PCO REVIEW FORM

Project Name: **Haverhill Consentino Middle School**

Subject: **PR-52 Cafeteria Clouds WJGI**

SUBJECT: PCO #150- PR-52 Cafeteria Clouds WJGEI Costs

LEVEL 2 REFLECTED CEILING PLAN - AREA C AND D

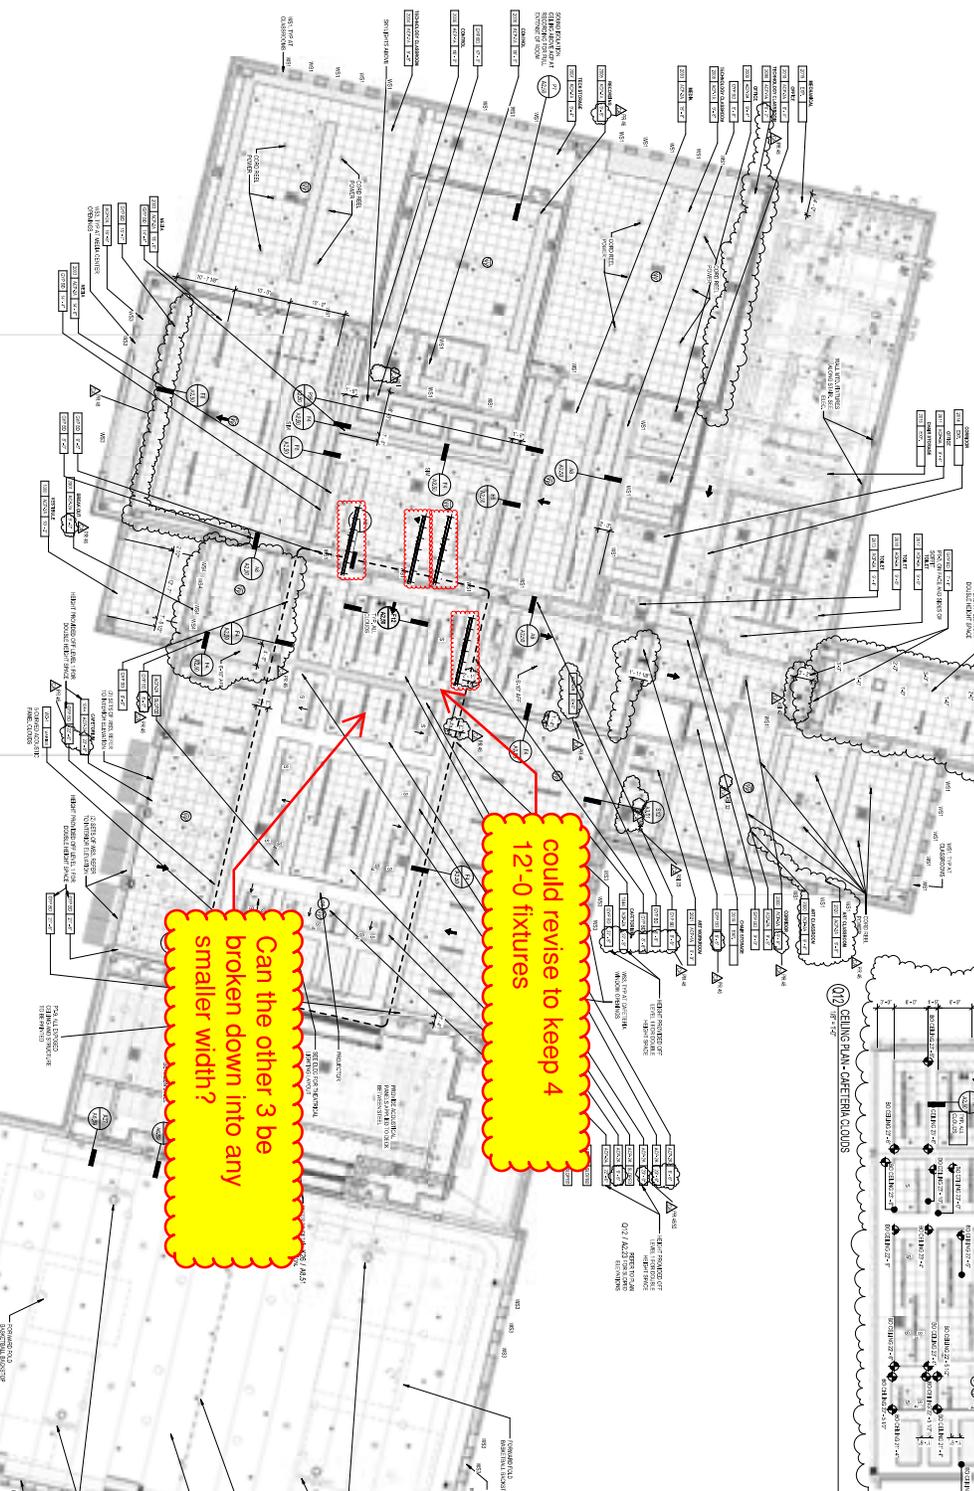
To remove five (5) LR12B Fixtures due to the new Cloud Ceiling Layout and Install the following in the new configuration:

- Two (2) - LR12B.
- Five (5) - LR8B.
- Seven (7) - LR4B.

To coordinate with steel joist seat along grid C7.0, revise cafeteria clouds at Q12, Ceiling Plan – Cafeteria Clouds as shown on the attached sheet, **A2.23**.

LEVEL 1 - AREA C - POWER PLAN
SCALE: 1/8" = 1'-0"

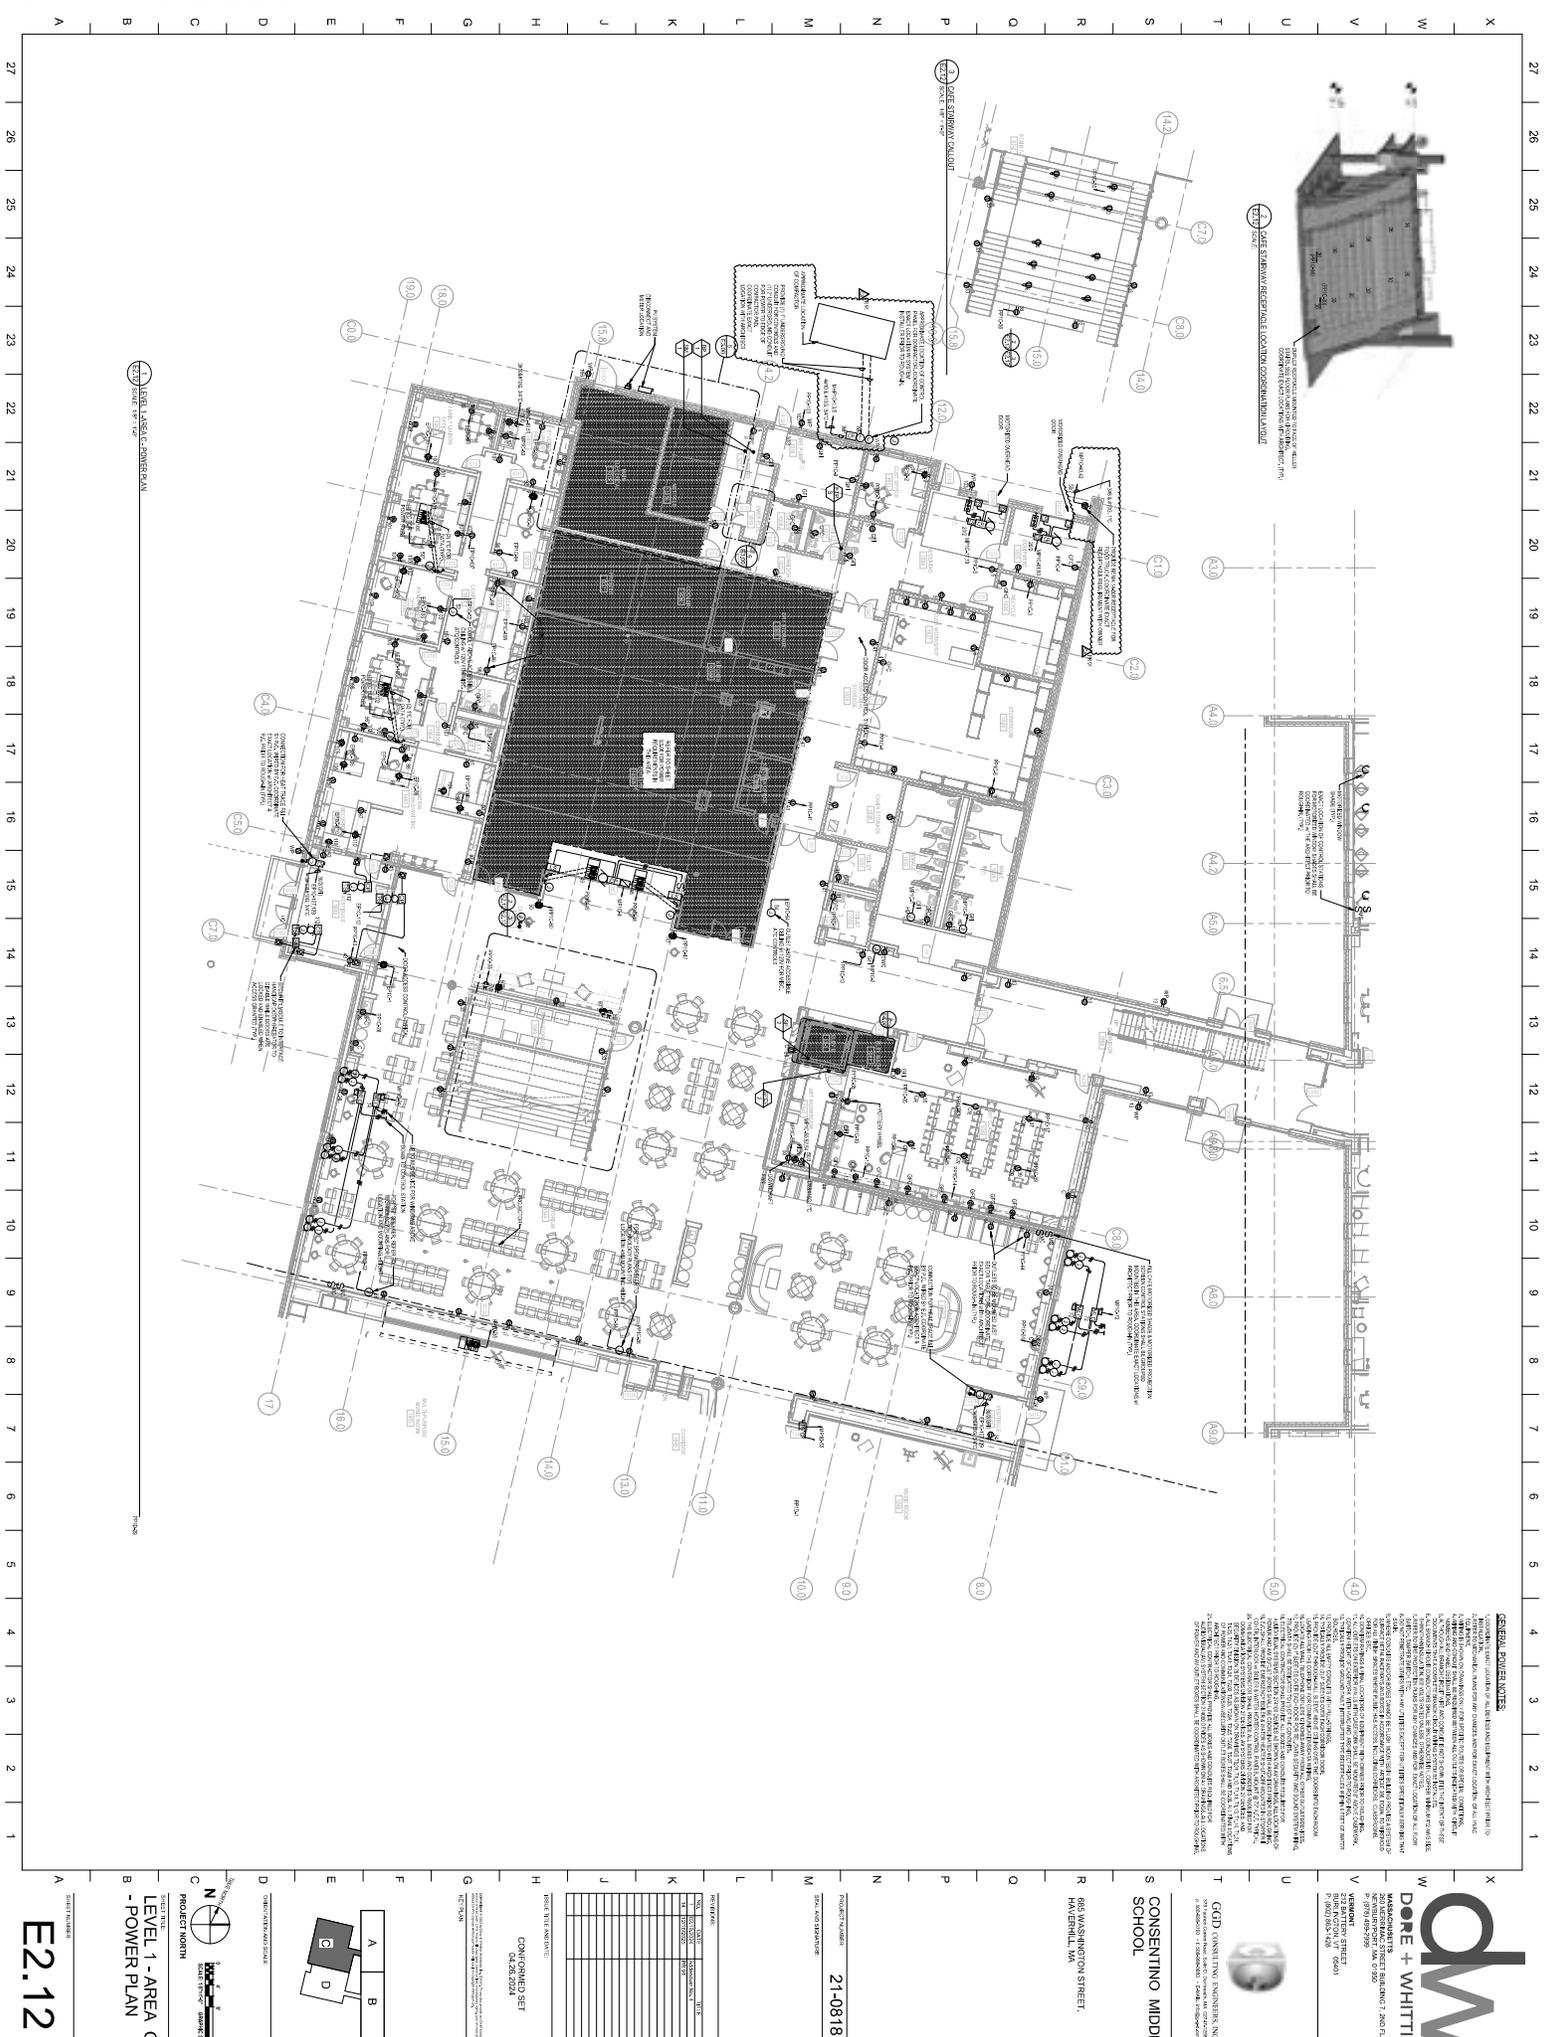
- To provide the labor and material for a complete system for the relocation of the Trash Compactor. The circuit owned by contract has already been installed at Door #1025A which will now be extended to the new location.
- The Mason will be required to remove a section of finished brick work to allow for the wall penetration required for the conduit. This will need to be re-sealed and brick work replaced, this work and cost is not included in our proposal.

- To provide the labor and material for a complete system for the added supply to the Food Truck. WJGEI will use a previously installed underground raceway to the Recycle Room and extend to the new location.

To coordinate with Owner Compactor / Equipment and Food Truck requests, refer to attached **E2.12**, LEVEL 1 – AREA C – POWER PLAN. Contractor to coordinate stub up conduit with edge of compactor slab for future connection.
